Subject: Suggestions in regard to Master Plan/Zonal Plan of Zone G

MODIFIED ZONAL DEV PLAN  
ZONE G WEST DELHI-I

Enclosure: Suggested plan for Zone G-18

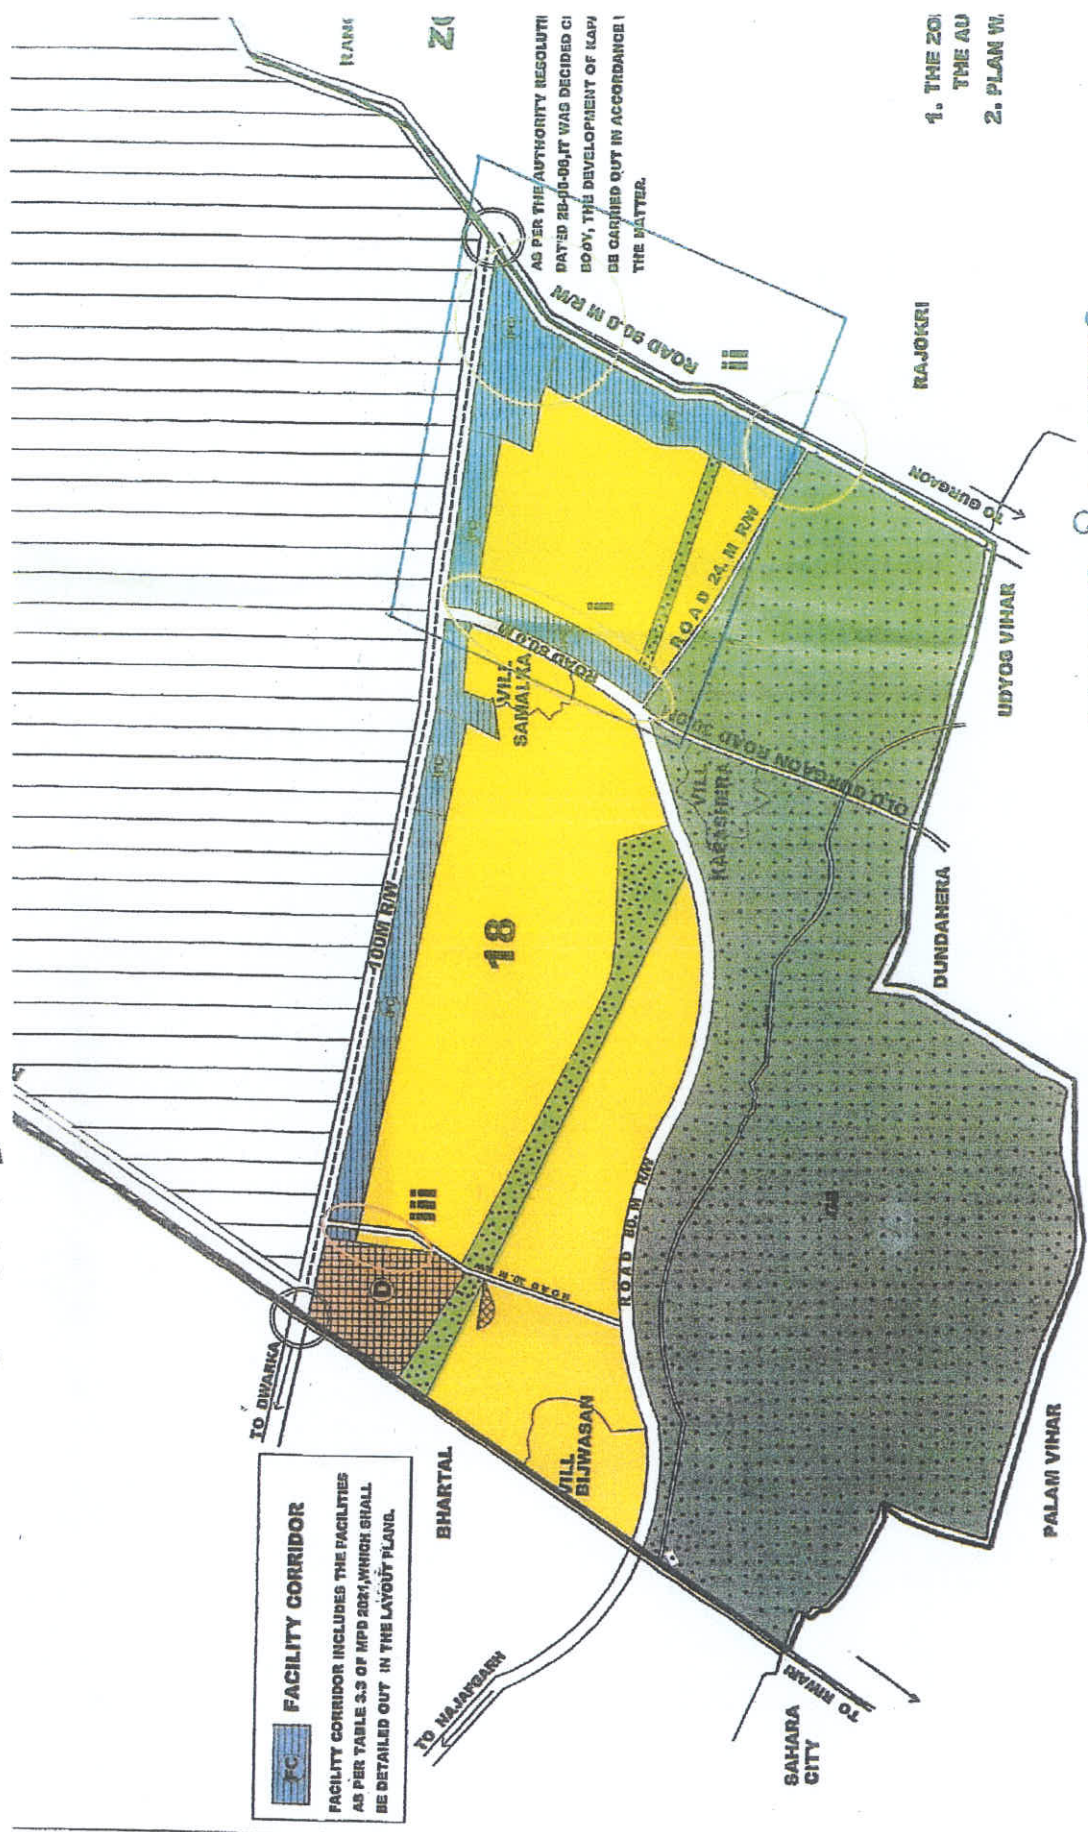
In the draft zonal plan for G-18 there is a proposed new 80m R/W road between the high tension lines extending the 80m R/W road that is between Village Bijwasan and Village Kapasehra all the way to NH-8 (90m R/W) and forming a T-junction with NH-8 and not continuing into Zone J. I would like to suggest that the proposed road is unnecessary and would be very disruptive to traffic flow in the area, particularly on NH-8 as it is meeting NH-8 very close to two nodes, one a T-junction for the 100m R/W road from NH-8 to Dwarka, and the second the beginning of the NH-8 flyover over Rajokri-Bijwasan Road. As traffic has been increasing significantly on NH-8 over the past several years, the additional intersection would be disruptive and create even greater traffic jams rather than help ease traffic. I would suggest instead to invest in clovers at the intersection of the 100m R/W Dwarka road with NH-8 and also broaden the Old Gurgaon Road through village Samalka between Kapasehra and the 100m R/W Dwarka road while creating a clover where Old Gurgaon Road meets the 100m R/W road. This would improve traffic flow on the 100m R/W Dwarka road as well as the 90m R/W NH-8.

I believe that the plan modified based on the recommendations of the Board of Hearing and Enquiry on objection/suggestion invited on the plan published on 17-12-2008 after its approval in Authority meeting held on 17-12-2008 vide item no. 87-2008 had the appropriate solution for G-18 with the commercial/residential block extending between a broadened 80m R/W Old Gurgaon Road to the West, Rajokri-Bijwasan Road to the South, a 100m R/W Dwarka Road to the North and a 90m R/W NH-8 to the East.
